**ADDENDUM NUMBER 2**

**Thursday, January 23, 2025**

**PROJECT: BRISCOE PARK  
COMMUNITY CENTER, GA  
GMC PROJECT NO. AATL2300037**

**C-300**  
 SHEET OF

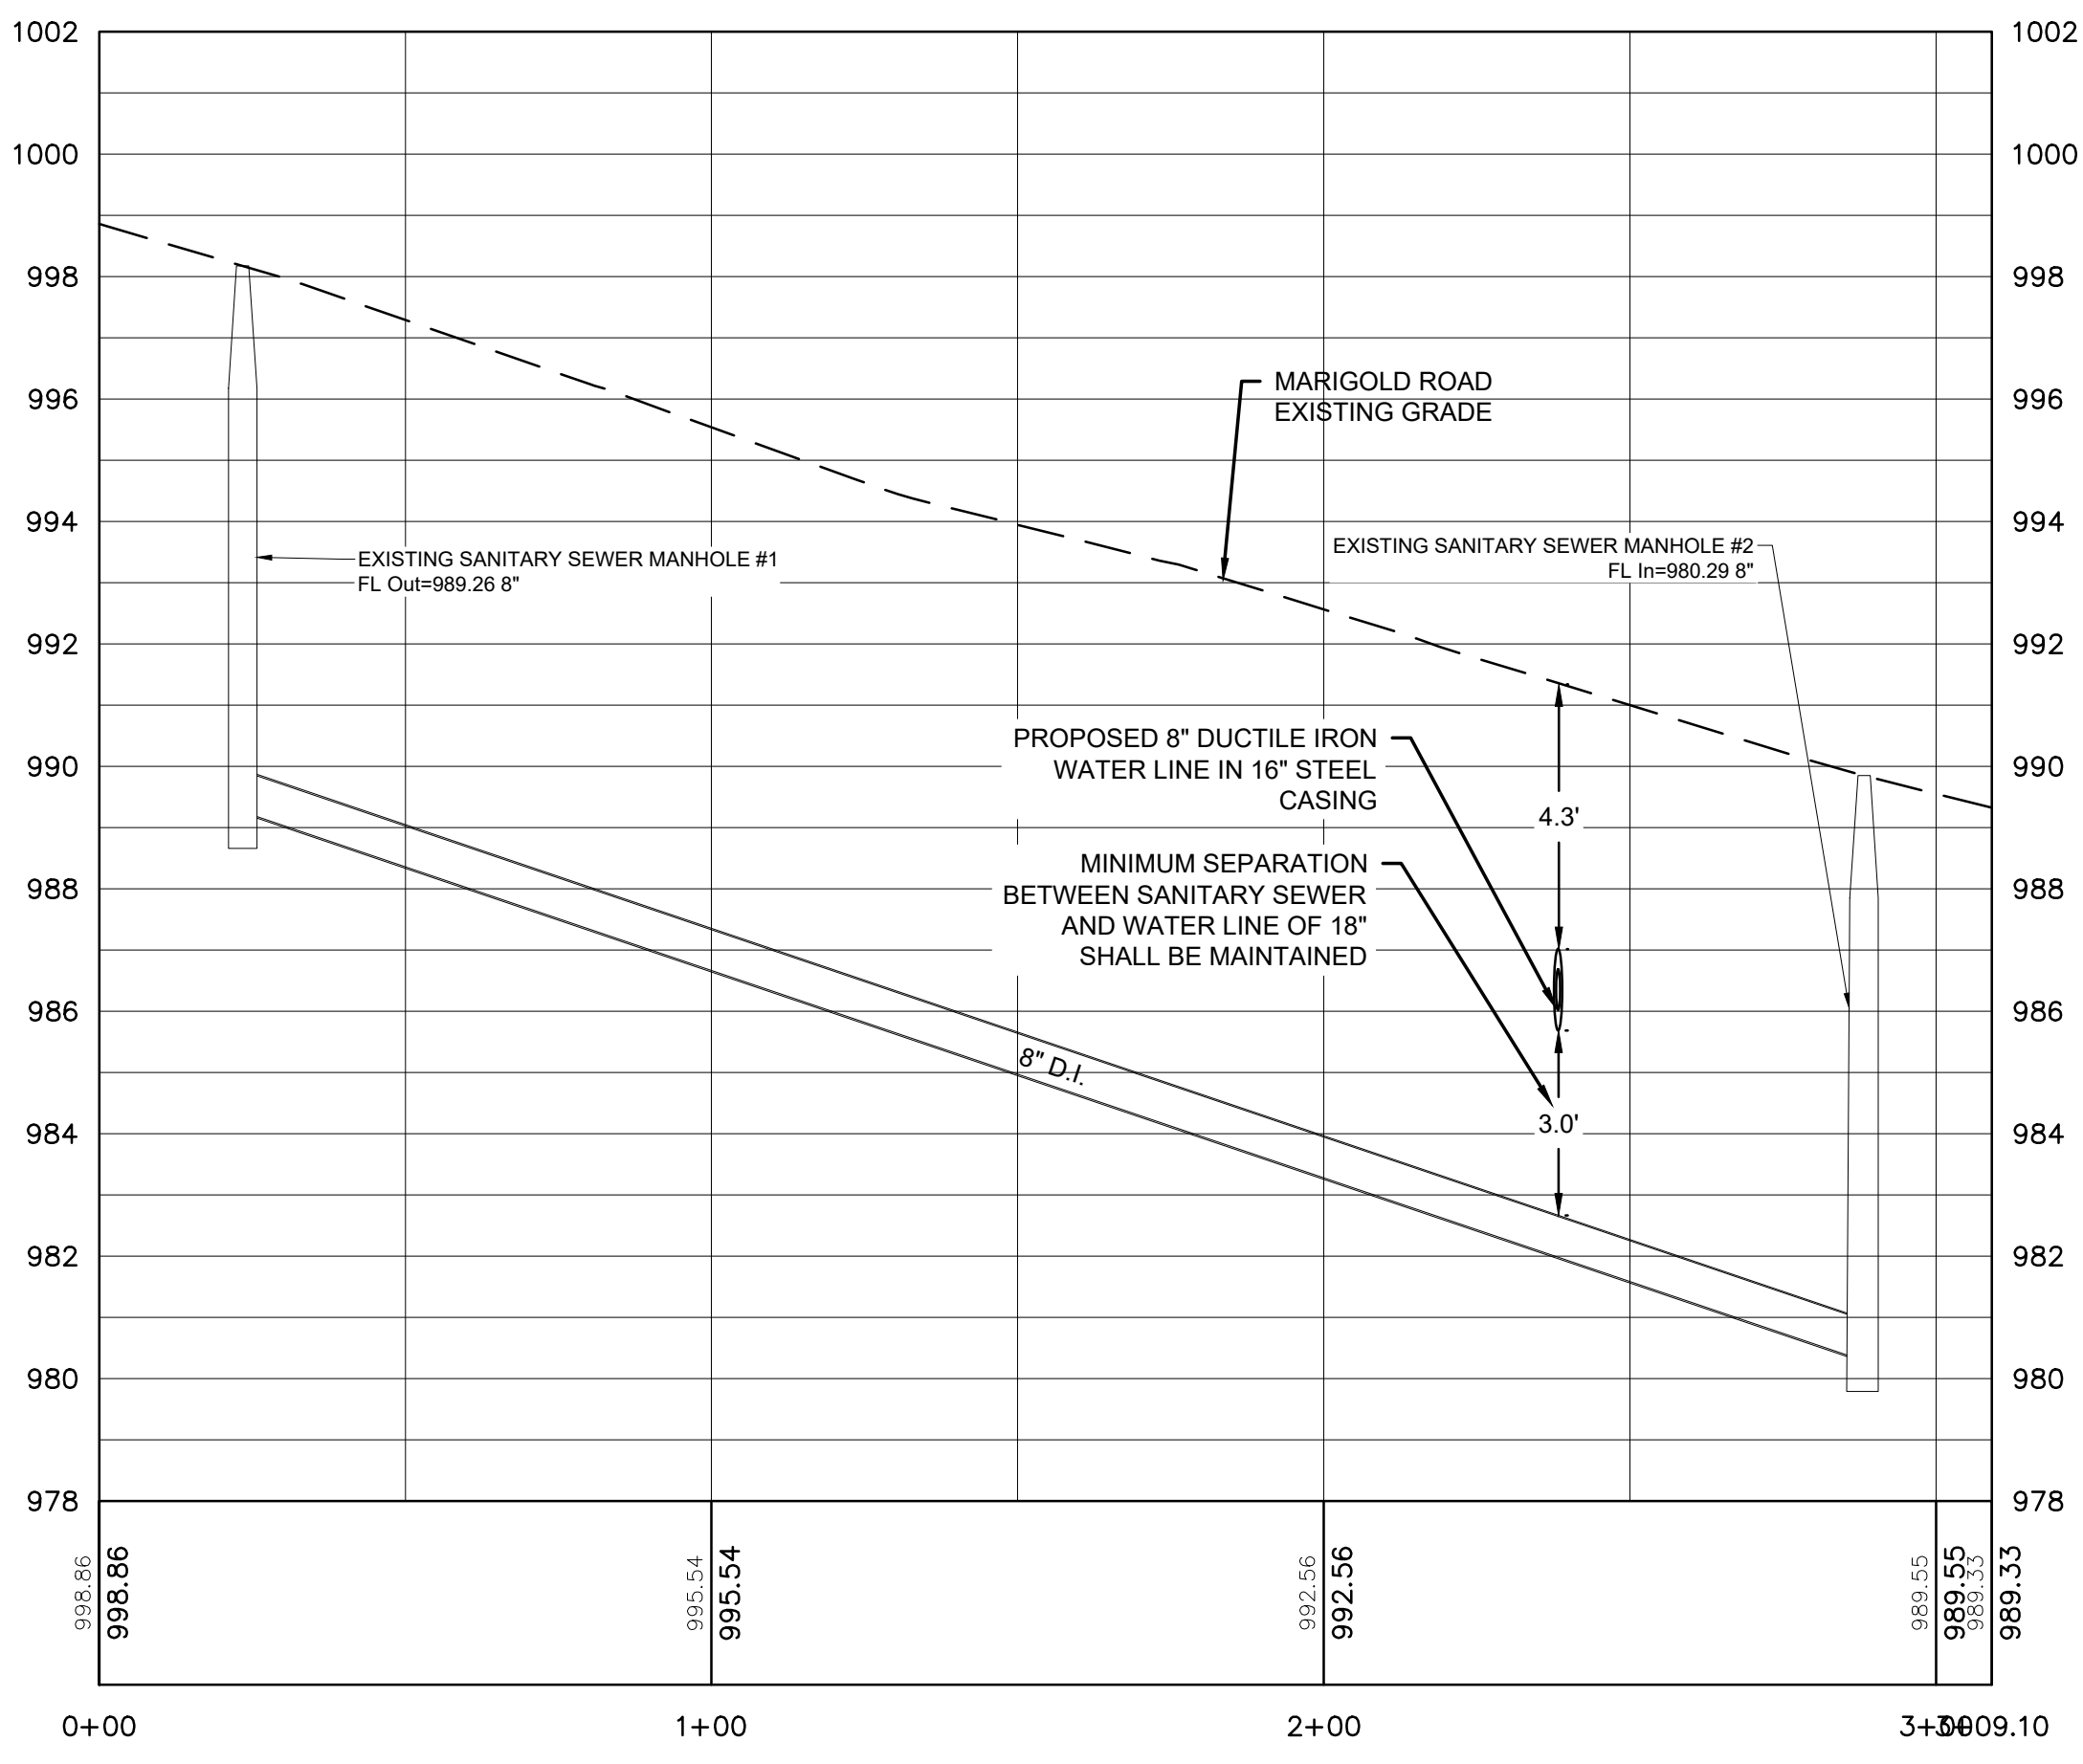
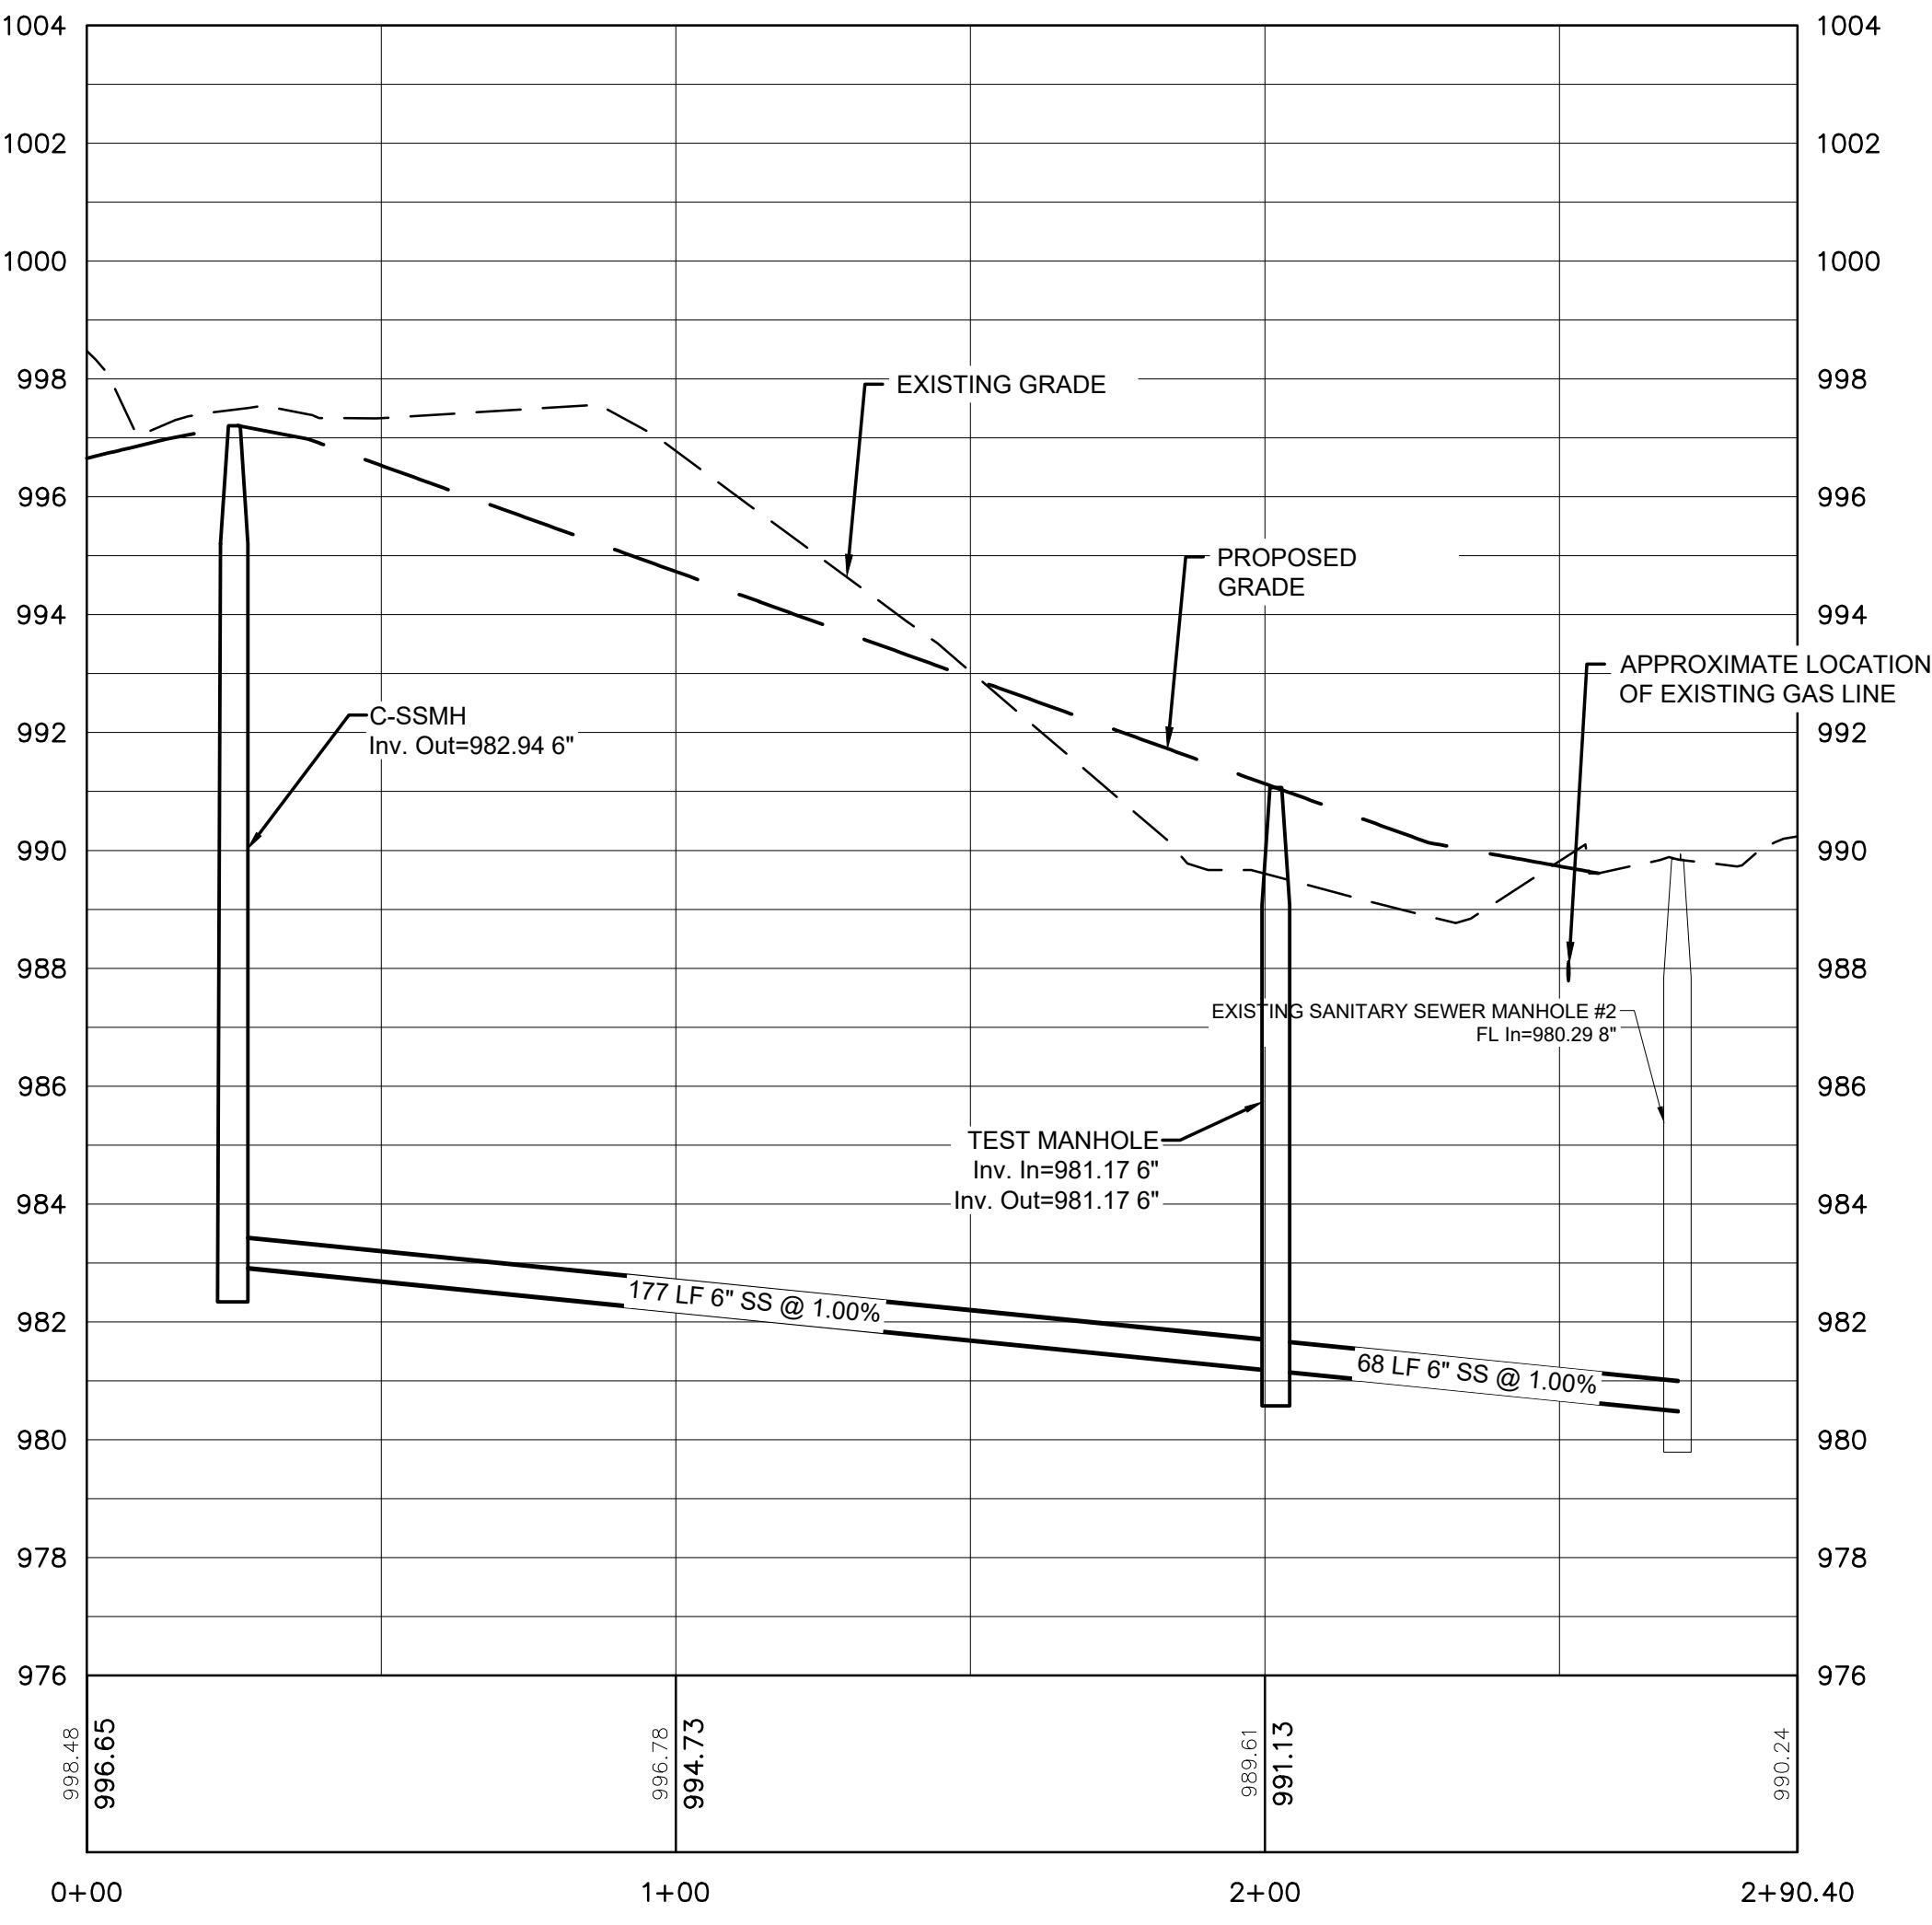
- A. C-001- PROJECT NOTES
  - 1. Updated with Gwinnett County notes
- B. C-100- SITE PLAN
  - 1. Required county water easement
- C. C-300- UTILITY PLAN
  - 1. Adjusted fire hydrant.
- D. C-302- WATER/SEWER PROFILE
  - 1. New drawing included
- E. C-902- DETAILS
  - 1. New drawing included
- F. C-903- DETAILS
  - 1. Updated to include concrete steps with handrails
- G. S1.01- OVERALL FOUNDATION PLAN
  - 1. Updated drawing to answer GC question
- H. S1.02 – OVERAL FRAMING PLAN LEVEL 2
  - 1. Updated drawing to answer GC question

Civil	2.Drawing C-001 utility note #29 says, "All storm pipe connections to manholes, inlets, junction boxes, etc. shall be made utilizing flexible boots." Using flexible boots (especially if precast is not allowed), will triple the cost of manholes. GDOT SPEC 668.3.05, B, 2, b says to "use mortar or Class A concrete to connect pipe to units." Is mortar or class A concrete per GDOT spec allowed instead of boots?	If it meets GDOT Standard Specifications, yes it will be allowed.
Civil	3.Will a profile (or at least top and invert elevations) be given for sewer line before bid?	Yes, and is shown on Sheet C-302
Civil	1. Drawing C-300-Due to traffic and load concerns, can the pump station in the fiberglass basin be moved out of the parking lot?	Lift Station has been adjusted to be behind the curb line and the shoulder has been widened to accommodate.
Civil	5.Drawing C-300-Will any additional information be given for the lift station such as, model #, etc.?	The pump manufacturer will design the station based on the information provided on Sheet C-300

Civil	7.Drawing C-300 labels roof drains as A2000 PVC. C-907 details roof drain connections with HDPE and injection molded fittings for HDPE. Is A2000 PVC required, or is HDPE also allowed?	HDPE is allowed and callout on Sheet C300 will be updated
Civil	8.Drawing C-300-Is 8" sewer between the existing sewer manhole and the first upstream manhole PVC or Ductile Iron?	PVC pipe and fittings shall be made in conformance with ASTM D3034 SDR 35 for 6 inches through 24 inches. PVC pipe and fittings shall be Schedule 40 for 4 inches and smaller diameters.
Civil	9.Drawing C-300-Is the 6" sewer lateral between the building and the pump station PVC or Ductile Iron?	PVC pipe and fittings shall be made in conformance with ASTM D3034 SDR 35 for 6 inches through 24 inches. PVC pipe and fittings shall be Schedule 40 for 4 inches and smaller diameters.
Civil	10.Is dual wall HDPE, SDR35, or SCH40 PVC an acceptable alternate for A2000 PVC?	HDPE is allowed and callout on Sheet C300 will be updated

CONCRETE WALL  
DETAILS

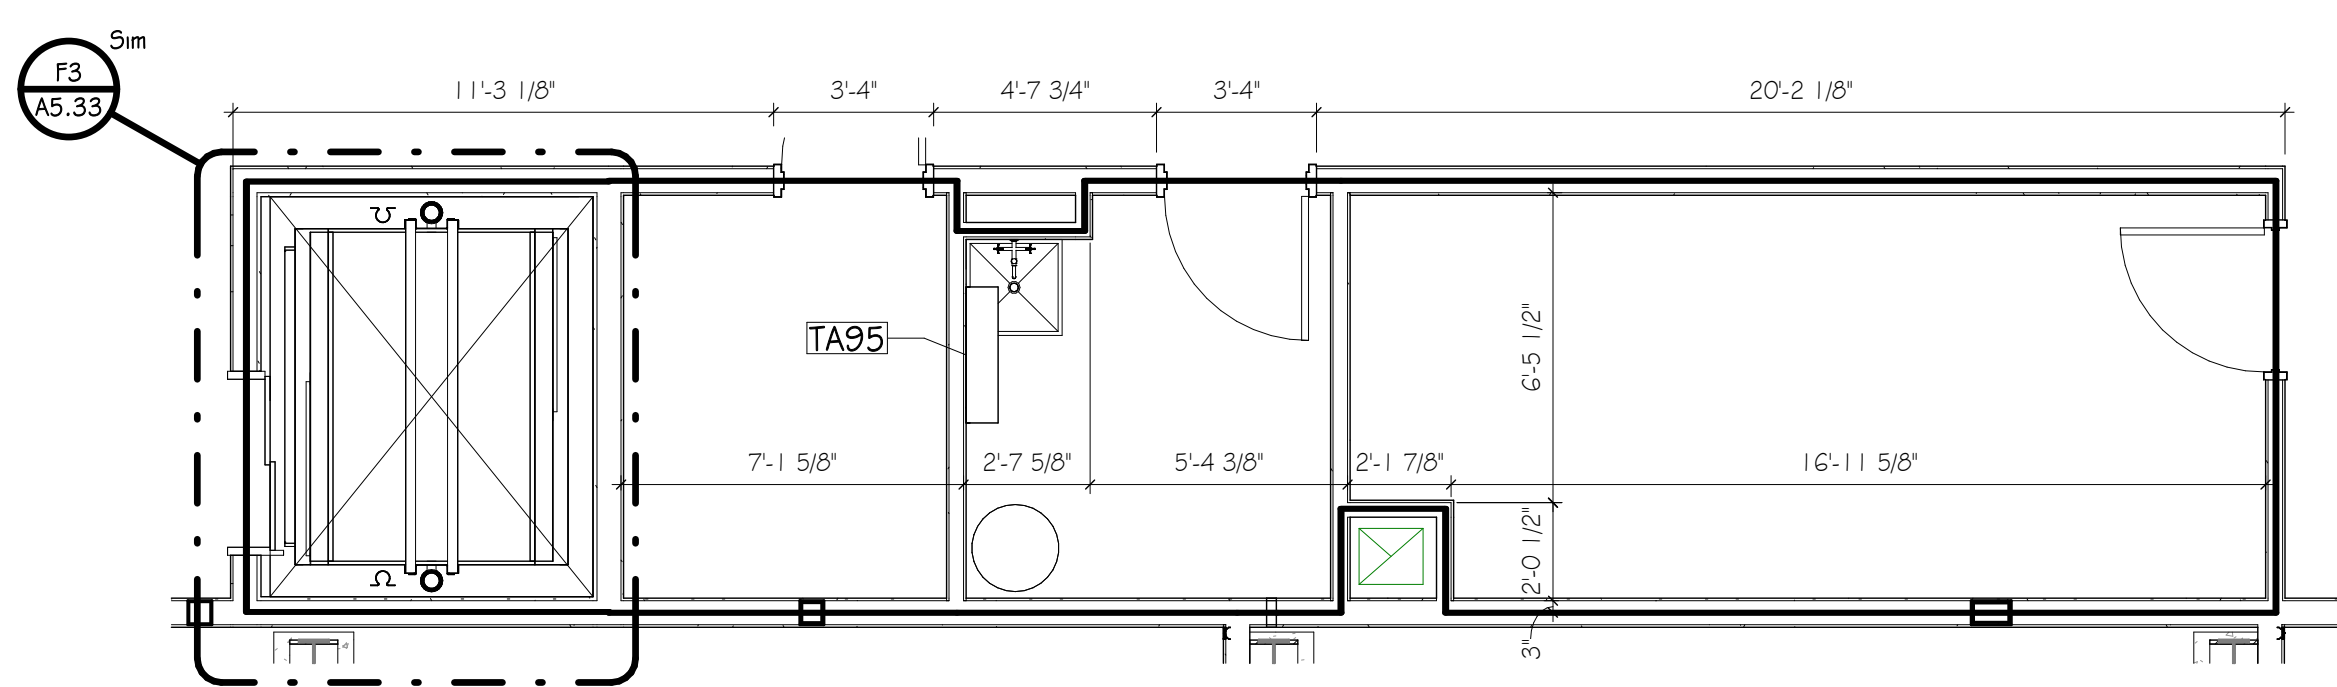
- I. S3.13 – CONCRETE WALL DETAILS
  - 1. Updated to show interior retaining wall elevation
- J. A1.11- ENLARGED PLANS
  - 1. Updated equipment types
- K. A1.21 – PLAN DETAILS
  - 1. Updated wrapped patio pilaster details
- L. A2.01- RCP LEVEL 1
  - 1. Showing roller shade locations and exposed ceiling areas
- M. A2.02- RCP LEVEL 2
  - 1. Showing roller shade locations and exposed ceiling areas
- N. A4.01- EXTERIOR ELEVATION
  - 1. Updated sunshade placements and signage
- O. A4.02- EXTERIOR ELEVATION
  - 1. Updated sunshade placements.
- P. A5.13 – WALL SECTIONS
  - 1. Section of Exterior Patio pilaster.
- Q. A7.01- INTERIOR ELEVATIONS TOILETS
  - 1. Updated type of toilets and finishes
- R. A8.01- FINISH LEGEND AND SCHEDULE
  - 1. Updated paint color.
